SUBMISSION ON SECTION 4 APPLICATION (STRATEGIC HOUSING DEVELOPMENT)**ABP-313994-22****Kilbarry SHD****RE: Construction of 319 residential units on Cork GAA Lands at Kilbarry, Cork**www.kilbarryshd.ie29th August, 2022

EXECUTIVE SUMMARY

The planning authority find that the proposed strategic housing development, in its current form and in the absence of the level of detail required for complete assessment, does not accord with the proper planning and sustainable development of the area and should therefore be REFUSED for the following reasons.

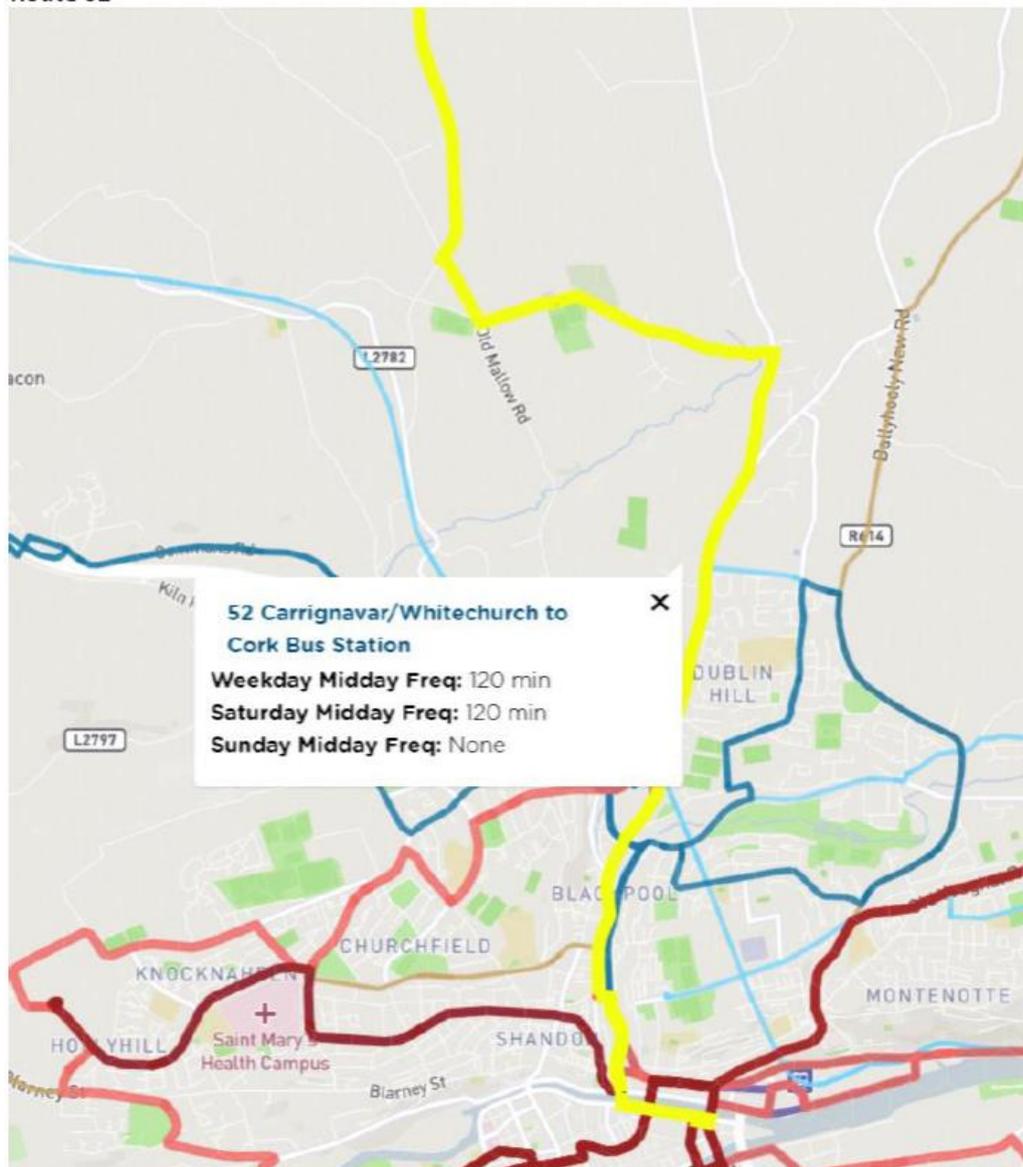
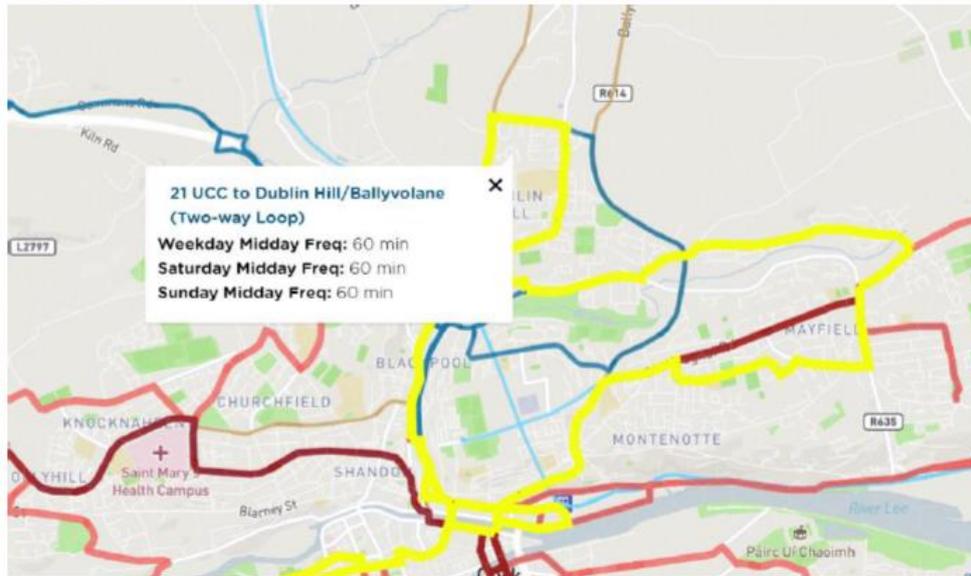
It is noted that the above bus routes are both low frequency routes at this time.

However, frequency and demand for services is reviewed by the NTA on an ongoing basis and increased frequency can be provided as demand increases.

12 Sustainable Transport Corridors (STCs)

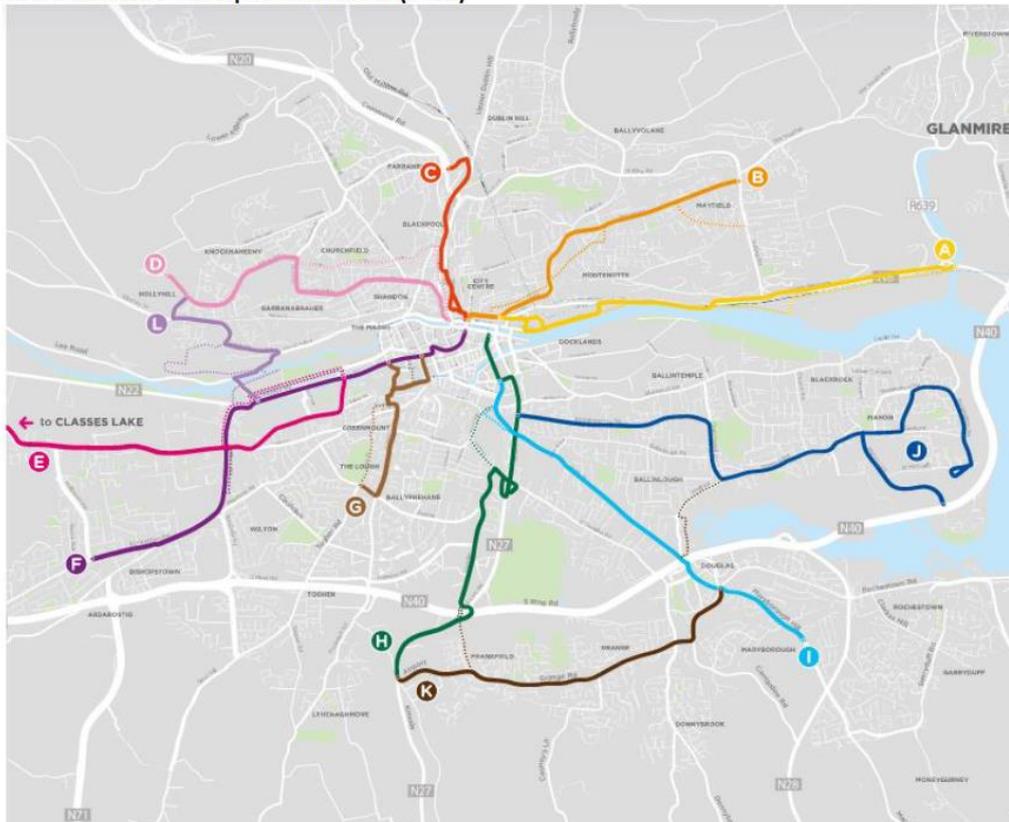
There are currently no STCs proposed that would support the proposed development. A screenshot showing the 12 proposed STCs is copied in below.
